Access Compliance Report

Public Rights-of-Way

Intersection ID: 11926	Main Street: WILKINSON_BV	Cross Street: BOYER_ST	Location: SW
ADA ID: 9322F8B824D4	Ramp Type: Perp	Initial Pass/Fail: Fail	Overall Compliance: No
		Severity Score: 10

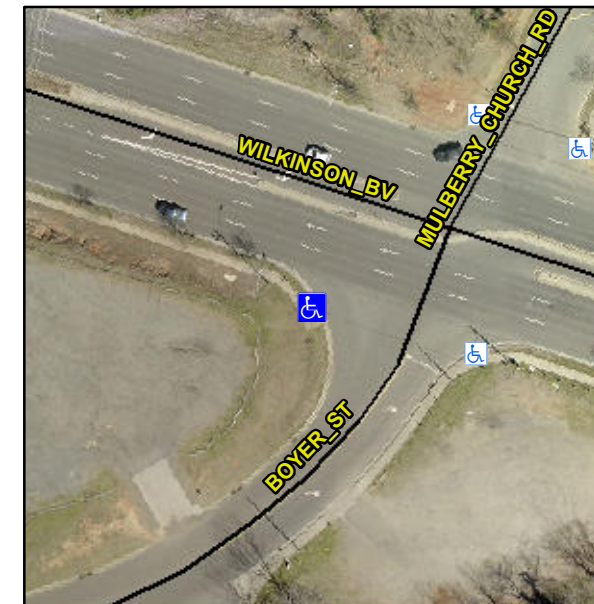
Not Found, R304.5.1, R304.5.3

Compliance	Description	Data	Compliance	Description	Data
N/A	Ramp Length (in)	108.0	Yes	Ramp Slope (%)	5.4
No	Ramp Width (in)	46.0	No	Ramp XSlope (%)	2.1
N/A	Flare Type LT	N/A	N/A	Flare Type RT	N/A
N/A	Flare Slope LT (%)	N/A	N/A	Flare Slope RT (%)	N/A
N/A	Flare Traversable LT?	N/A	N/A	Flare Traversable RT?	N/A
N/A	Landing Length (in)	N/A	N/A	DWS Provided?	N/A
N/A	Landing Width (in)	N/A	N/A	DWS Contrast?	N/A
N/A	Landing Slope (%)	N/A	N/A	DWS Length (in)	N/A
N/A	Landing X Slope (%)	N/A	N/A	DWS Full Width?	N/A
N/A	Landing Curb? (Y/N)	N/A	N/A	DWS Offset (in)	N/A
N/A	Shared Landing?	N/A			
N/A	Gutter Ponding?	N/A	N/A	Gutter Slope (%)	N/A
N/A	Gutter Lip Ht (in)	N/A	N/A	Gutter X Slope (%)	N/A
N/A	Painted X Walk1?	No	N/A	Painted X Walk2?	N/A
	X Walk 1 Direction	To SE		X Walk 2 Direction	N/A
N/A	X Walk 1 Width (in)	N/A	N/A	X Walk 2 Width (in)	N/A
	X Walk 1 Slope (%)	2.7		X Walk 2 Slope (%)	N/A
	X Walk 1 X Slope (%)	1.0		X Walk 2 X Slope (%)	N/A

Remove & Replace Entire Ramp.
